## STAFF REPORT

### CITY OF COLUMBUS PLAN COMMISSION (July 10, 2013 Meeting)

**Docket No. / Project Title:** PUDF-13-03 (Columbus Crossing Strip Center (Lots 10 & 11))  
**Staff:** Allie Keen  
**Applicant:** Menard, Inc.  
**Property Size:** 2.16 Acres  
**Current Zoning:** PUD (Planned Unit Development)  
**Location:** Southwest corner of Jonathon Moore Pike (State Road 46) and Morgan Willow Trace, adjacent and west of Wendy's, in the City of Columbus

Menard, Inc. is requesting approval of a Final PUD for Lots 10 and 11 of the Columbus Crossings Major Subdivision 4<sup>th</sup> Replat. The proposal is for a 9,025 square foot multi-tenant strip center.

Columbus, Indiana  
Strip Center Siteplan  
June 26, 2013  
Scale: 1" = 20'-0"

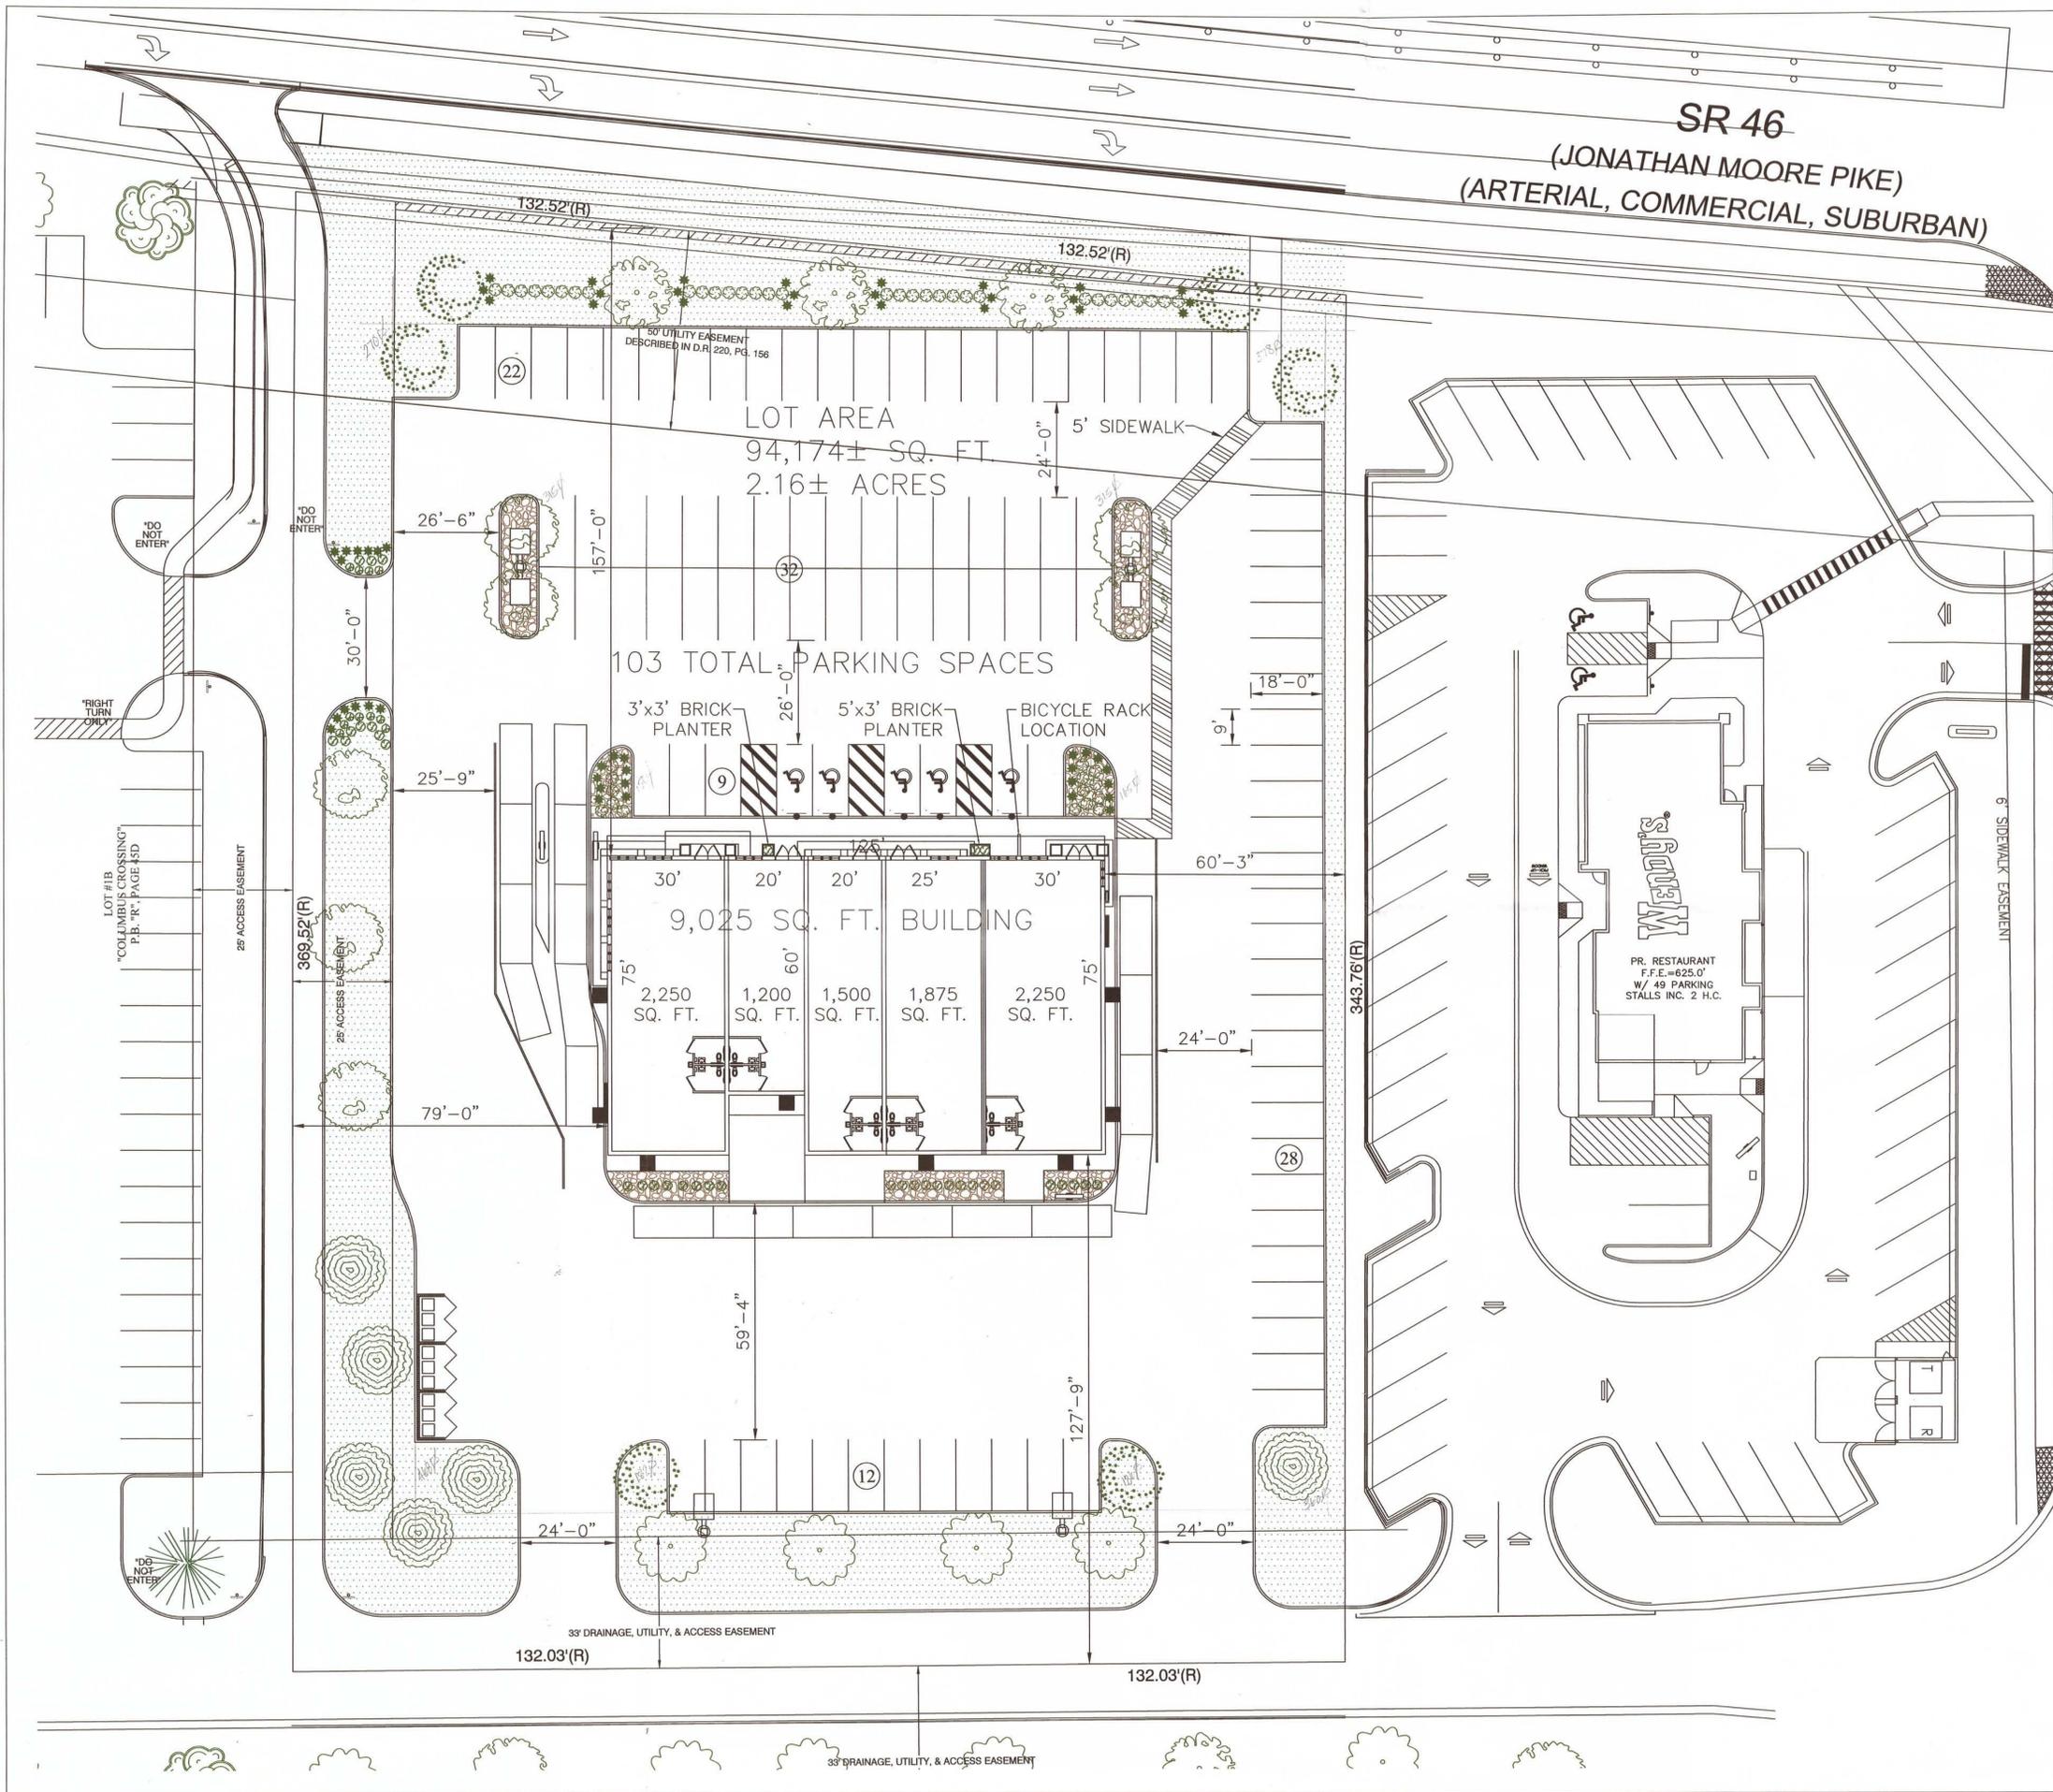
1. An administrative subdivision will be completed to remove the interior lot lines.
2. A Certificate of Elevation, which is a certified statement that verifies a structure's elevation information, must be submitted and approved by the Planning Department because the subject properties are located within the 100-year floodway fringe.
3. Drainage and erosion control plans must be submitted and approved by the City Engineering Department.
4. Landscaping requirements in Section 8 of the current Zoning Ordinance shall be met, which includes the following:
  - a. Replacing the 3 ornamental trees within Landscape Area #1 (Parking Lot Public Street Frontage) with either large or medium trees.
  - b. Provide an additional 21 shrubs within Landscape Area #2 (Parking Lot Interior) planting areas.

- c. All shrubs will be planted at a minimum of 18 inches in height, which will be indicated on the site plan.
- 5. Additional landscaping shall be provided along the north side of the building that is consistent with similar treatments for the other properties within the PUD, specifically Wal-Mart and Wendy's.
- 6. Replace all dying or missing landscaping, as shown on the preliminary PUD, that is associated with the two subject properties and indicate their locations on the site plan.
- 7. The pedestrian crosswalk shall be relocated to provide a safer route for pedestrians. This new crossing must be provided on the site plan and approved by the Planning Department.
- 8. All outstanding engineering and fire department comments must be met.

<b>Interdepartmental Review:</b>	
<b>City Engineering:</b>	<ol style="list-style-type: none"> <li>1. No site drainage information has been provided. We need to see a proposed drainage plan for stormwater review; a storm sewer is available but capacity is limited, therefore onsite detention and discharge rate reduction is required.</li> <li>2. The proposed sidewalk connection to SR 46 should be an accessible route with ADA compliant ramps.</li> <li>3. The proposed drive-thru lanes should meet the criteria set out in the Zoning Ordinance including lane width and number of stacking spaces. The proposed number of spaces appears to be too low.</li> <li>4. Parking dimensions for space size and aisle width on the site should meet the criteria in the Zoning Ordinance. At the east end of the building, dimensions should be redesigned to allow a 24 foot wide drive aisle, as required by the Ordinance, without encroachment into the drive-thru lane or a pedestrian walkway (the proposed PUD show a 22 foot aisle with a superimposed 5 foot walkway).</li> <li>5. The turning radius on the southeast corner of the building (for the east drive-thru) is too tight and needs to be enlarged for cars to properly maneuver around the corner.</li> </ol>

<b>City Utilities:</b>	No comments have been received.
<b>Fire Department:</b>	After looking at the plans provided, I do not see any water hydrants either existing or proposed. So that could be an issue if none are existing.
<b>Code Enforcement:</b>	No comments have been received.

1. The site plan has two proposed drive-thru windows (east and west side). The site plan shows 10 stacking spaces for the east drive-thru, but only 9 spaces for the west drive-thru. The applicant has indicated that the two proposed tenants for these spaces only require 5 stacking spaces and are not concerned with traffic backing up. Although the applicant does not see an issue, in the event of a different business moving into those spaces, backed up traffic could become an issue if the drive-thru is utilized more with a different business. Additionally, with two proposed drive-thrus the traffic circulation on-site could be difficult or hazardous to both motorists and pedestrians. Vehicles using the east drive-thru can only exit the property from the two south entrances. This requires vehicles to navigate through the northern parking area and the other drive-thru lines to exit the property. This area will have the most vehicles parked and pedestrians walking because of the front access to the building.

2. The current site plan provides a pedestrian crossing from the sidewalks along Jonathon Moore Pike to the building entrances. As it is currently shown, the crossing is primarily located in a drive aisle and crosses in front of one of the drive-thru lanes, which could potentially be hazardous for pedestrians. It was recommended to the applicant that this crosswalk is shifted to make a safer path for pedestrians.

3. The proposed site plan shows minimal landscaping, 3 shrubs, along the front of the building. Other properties within the PUD have paid special attention to foundation plantings by provided larger plantings, such as ornamental or small trees in addition to shrubs, along a majority of the building.

4. The existing street trees that were planted as a part of the original PUD will be relocated and incorporated into the landscape plan. However, those locations need to be identified on the site

plan. Additionally, the original PUD landscape plan shows 5 street trees along Jonathon Moore Pike, and currently there are only 2 trees on the site in this location. These trees are also not shown on the site plan.
